BID ADDENDUM NO. 2

OWNER: EDGEMONT UNION FREE SCHOOL DISTRICT

PROJECT NAME: HIGH SCHOOL BUILDING 'A'
INTERIOR RENOVATIONS

DATE: October 28, 2025

PROJECT TITLE
EDGEMONT HIGH SCHOOL BUILDING A
RENOVATIONS
300 WHITE OAK LANE, SCARSDALE, NY 10583
DRAWING TITLE
INTERIOR ELEVATIONS

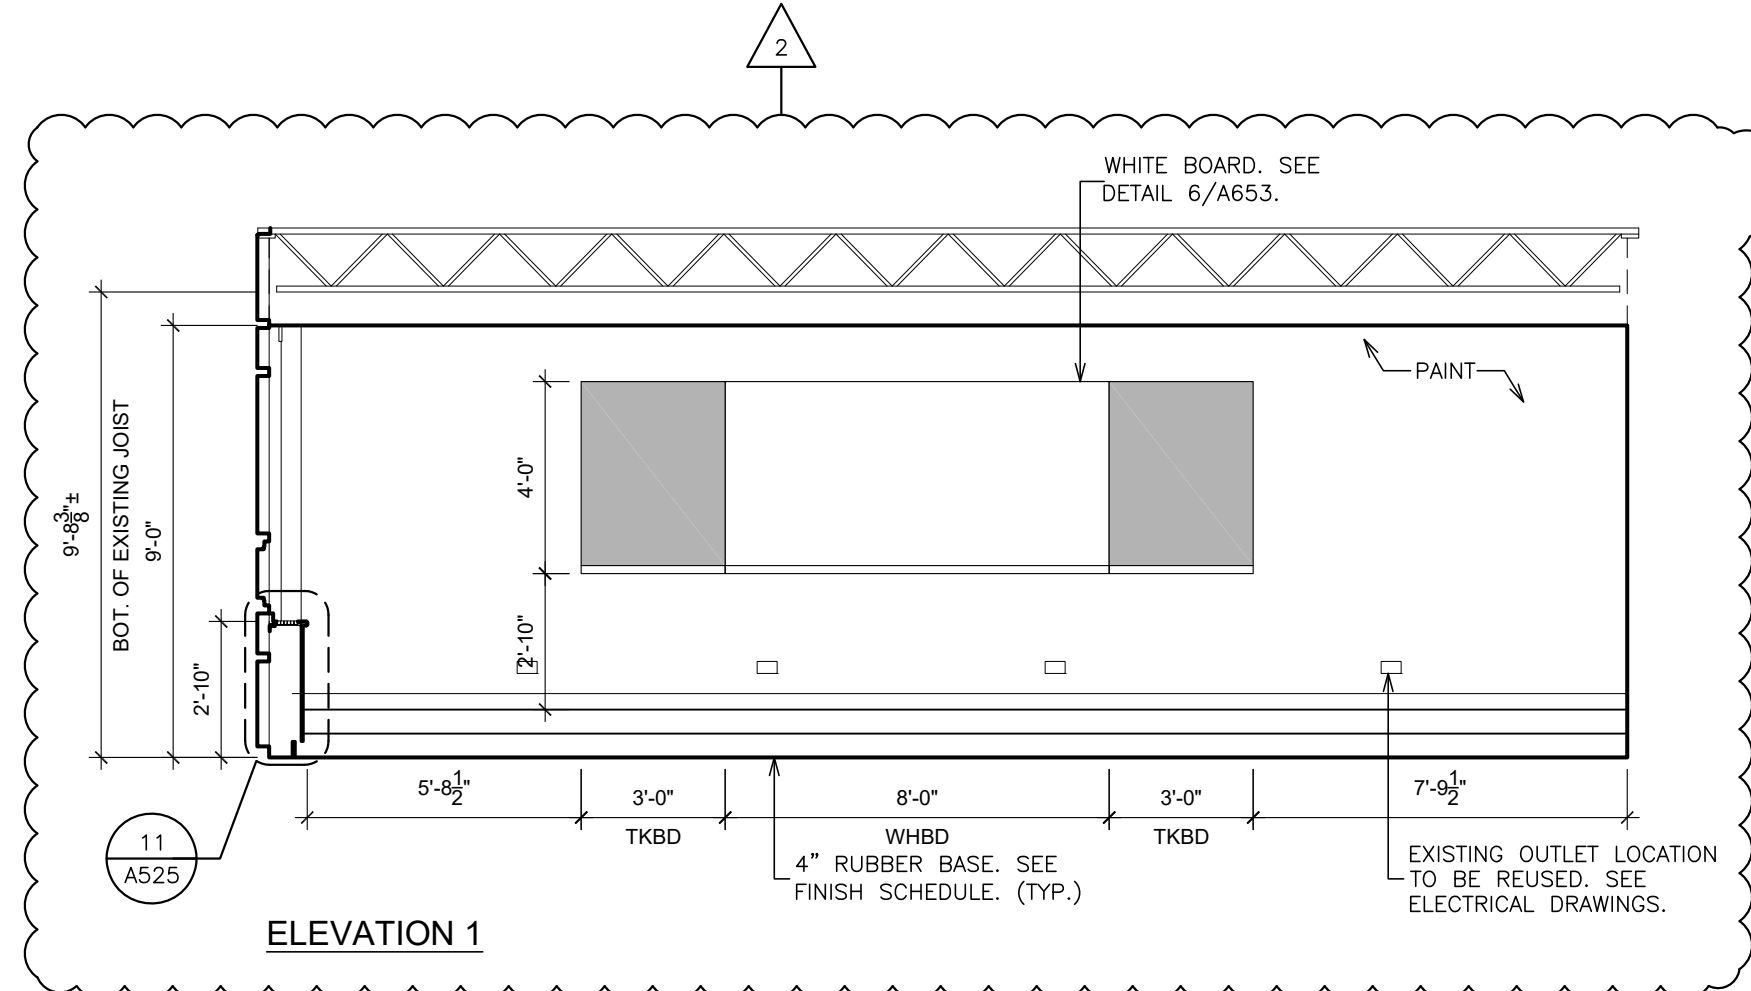
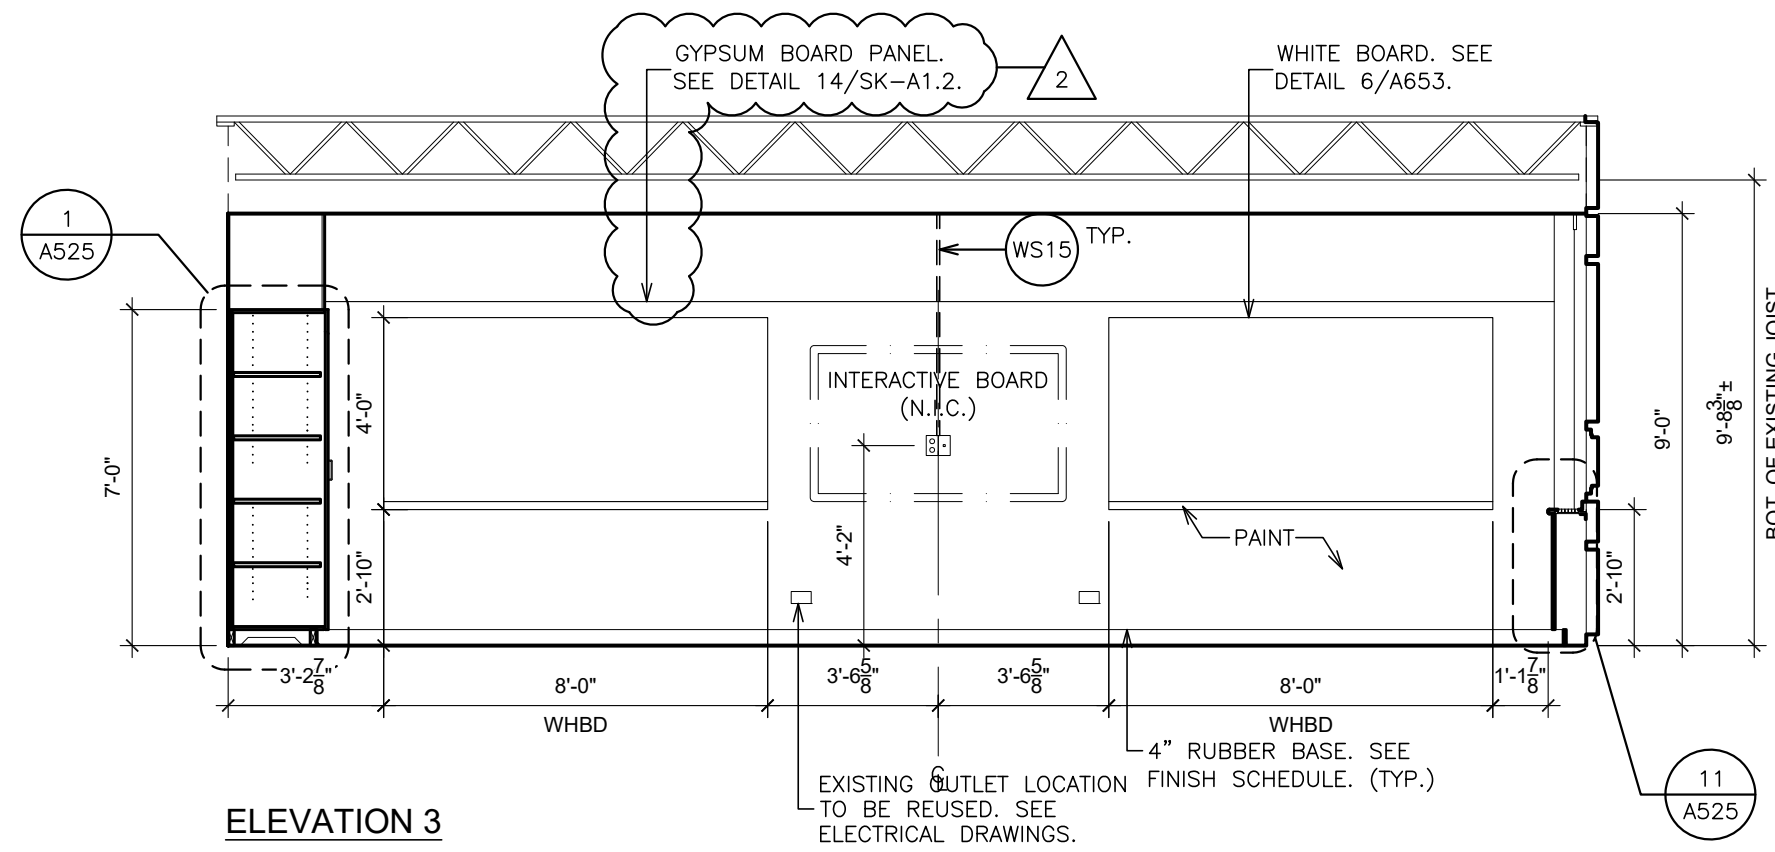
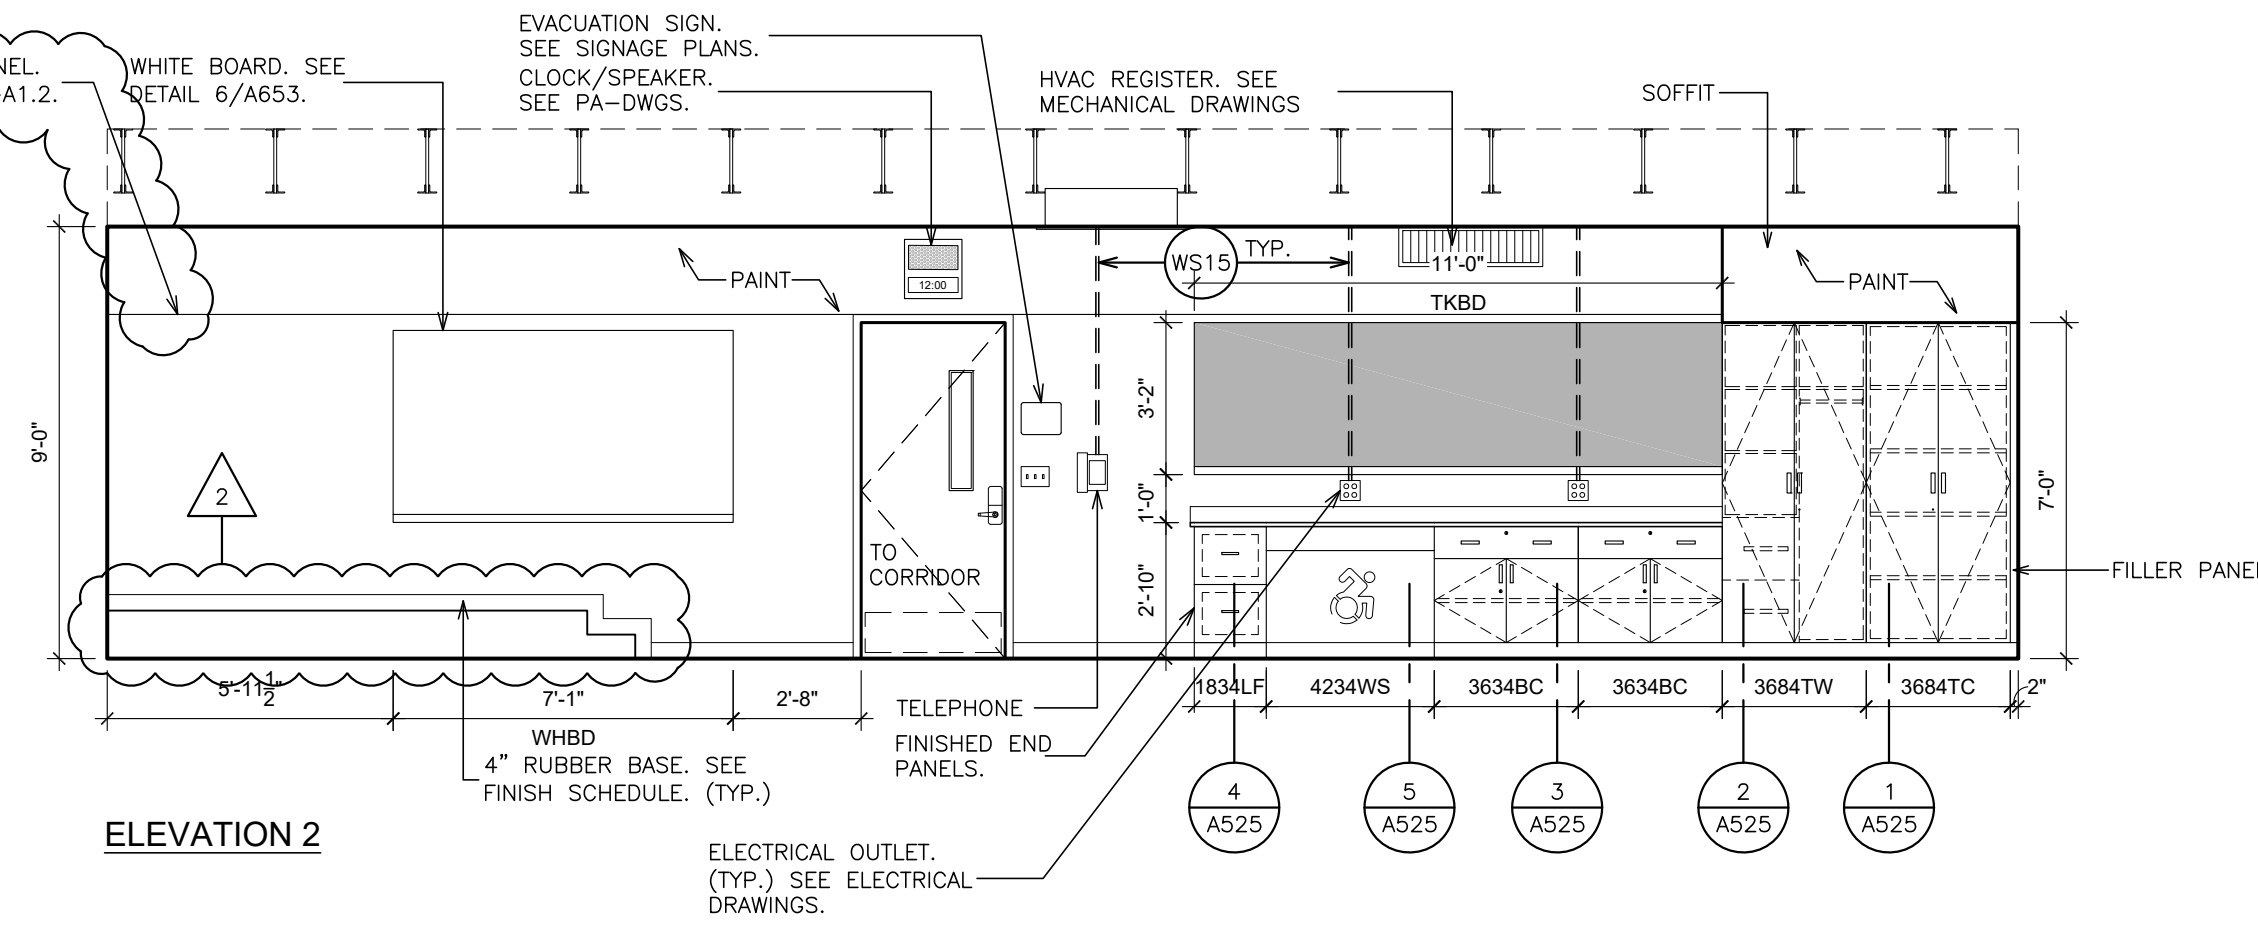
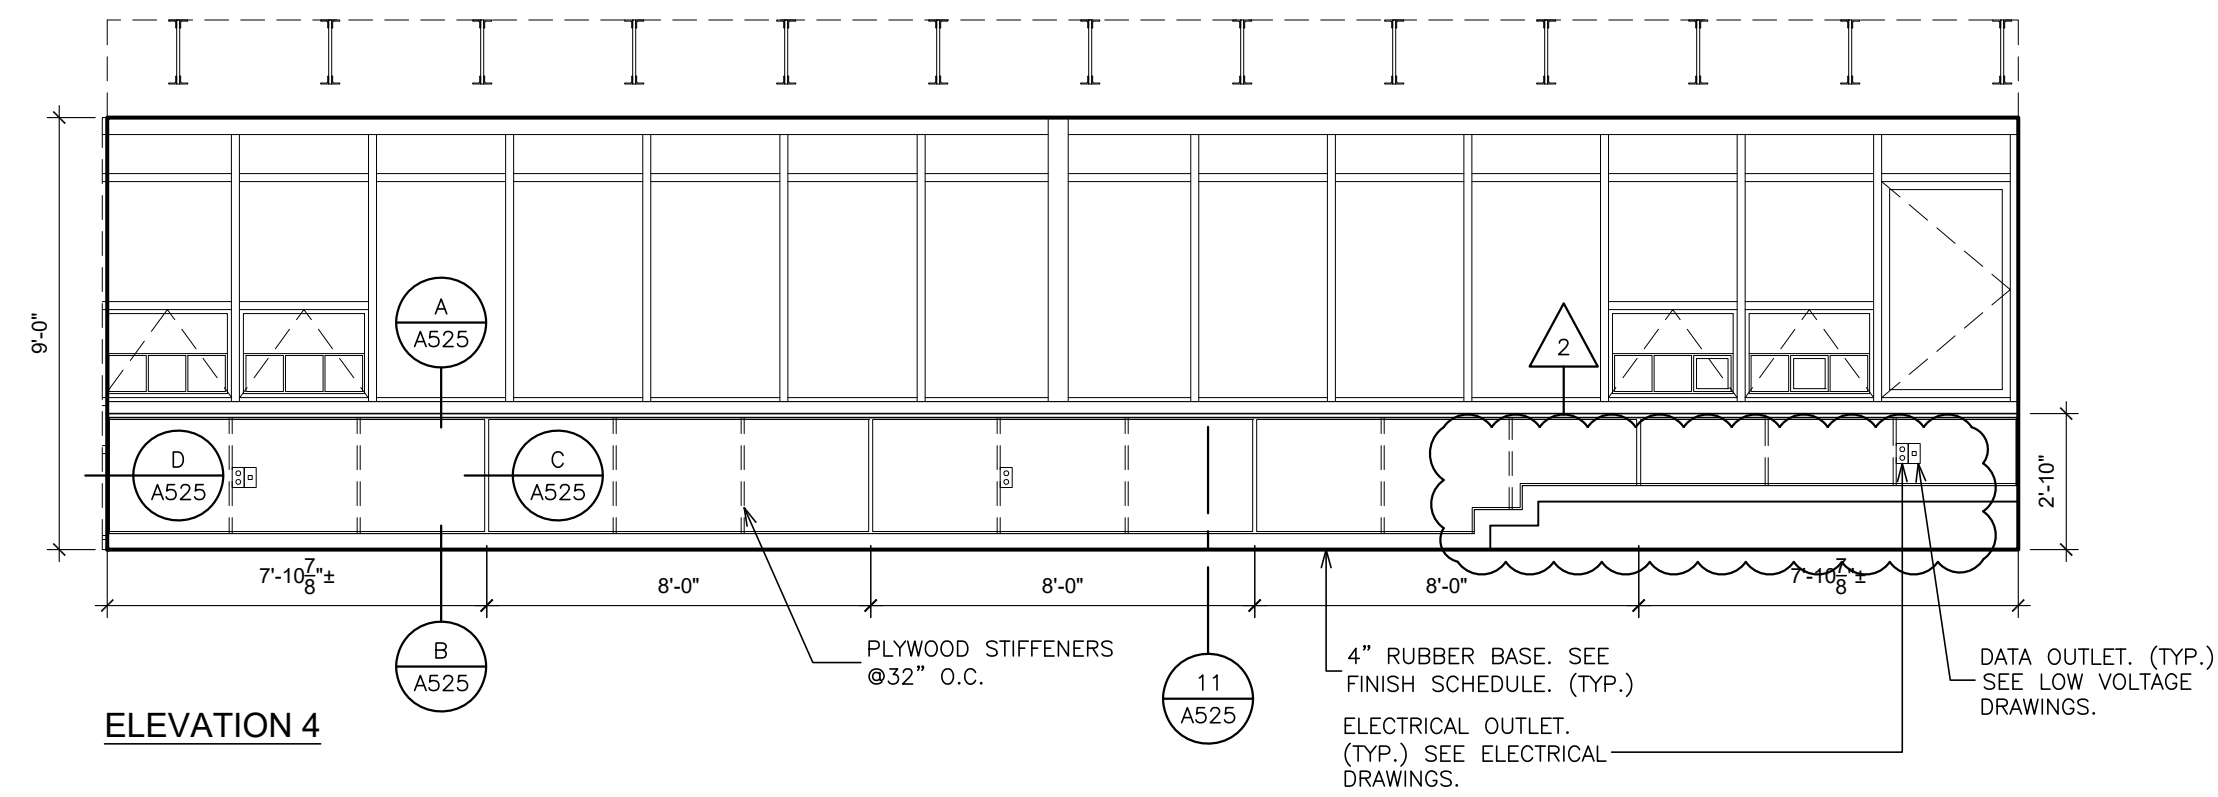
DRAWING A110 – INTERIOR ELEVATIONS

Detail 1, refinish existing wooden stage and risers as shown on revised drawing attached to this addendum.
